INDESIT company

Model type:
IDL75SEU.2

Commercial code:
F032845

N1045072FIG1

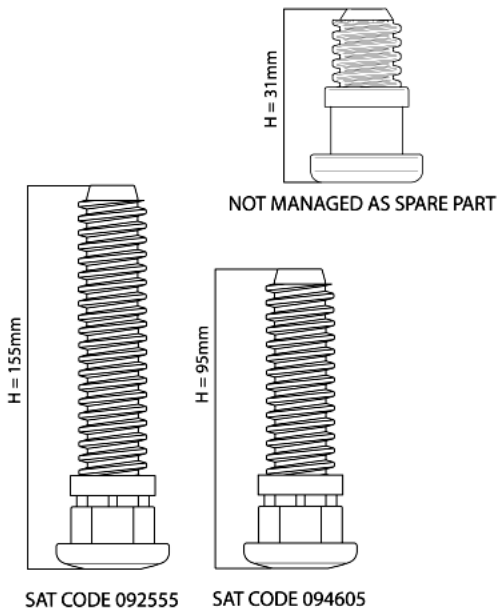
N1045072: Introduction of fixed rear foot H=31mm on free-standing models.

From serial no. 40218.0001, free-standing dishwashers affected by this modification have been equipped with new fixed rear feet (H=31mm).
The new foot replaces the adjustable one (H=155mm) Service code 092555; on the EVO3 range with TurboDry the new foot replaces the adjustable foot (H=95mm) Service code 094605.
The Spare Part Warehouse will continue to manage only 155mm and 95mm adjustable feet as they are interchangeable with the fixed 31mm foot.
The three feet are shown in illustration N1045072FIG1.

N1045083FIG1

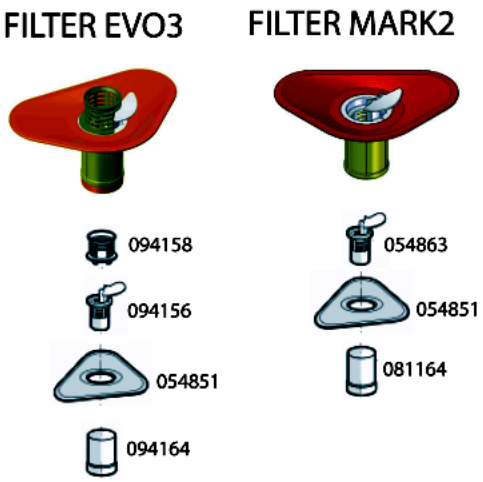
n1045083: Modification of filters on EVO3 60 cm dishwashers

All dishwasher models affected by this modification have been equipped with the items listed below, in order to solve the drain pump clooging problem.

Introduction of:
Cylindrical plastic filter code 081164
Central filter code 054863

Elimination of:
Cylindrical plastic filter code 094164
Central filter code 094156
Central filter grid code 094158

The modification has been introduced progressively, starting from serial no. 40516.0001.

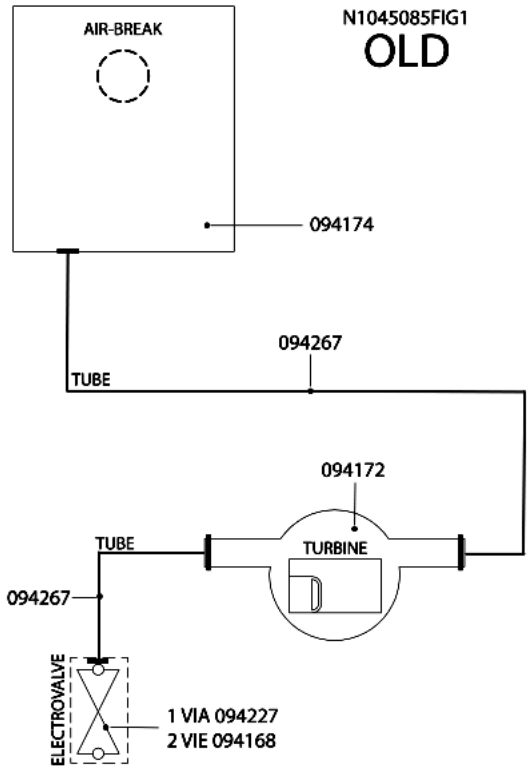
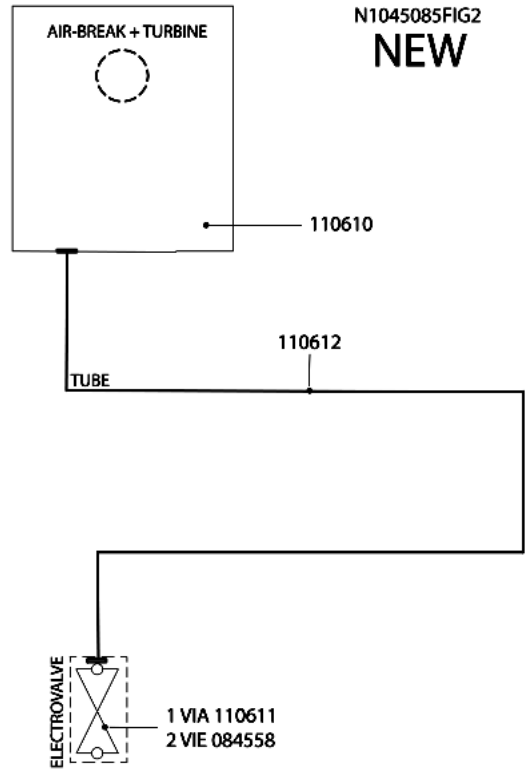
n1045085: Introduction of new litre counter turbine integrated on air-break.

All dishwashers affected by this note have been equipped with a new litre counter turbine on the air-break.
Picture N1045085FIG1 illustrates the premodification structure, picture N1045085FIG2 the new structure.

AIR-BREAK:
new 110610;
premodification 094174;
the new item features a new integrated litre counter turbine and its water supply hose has a smaller diameter.

LITRE COUNTER TURBINE code 094172 has been eliminated.

SOLENOID VALVES:
new:
1-WAY code 110611;
2-WAY code 084558(Rohs 143737);
premodification:
1-WAY code 094227;
2-WAY code 094168;
the new solenoid valves have a smaller diameter drain hose fitting.

HOSES:
new solenoid valve hose/air-break code 110612;
premodification turbine hose/air-break code 094267;
premodification solenoid valve hose/air-break code 094267;
the new hose has a smaller internal diameter.

WIRING:
the litre counter turbine connecting cable is longer, but since the connector is the same, the new item can be used in place of the premodification one.
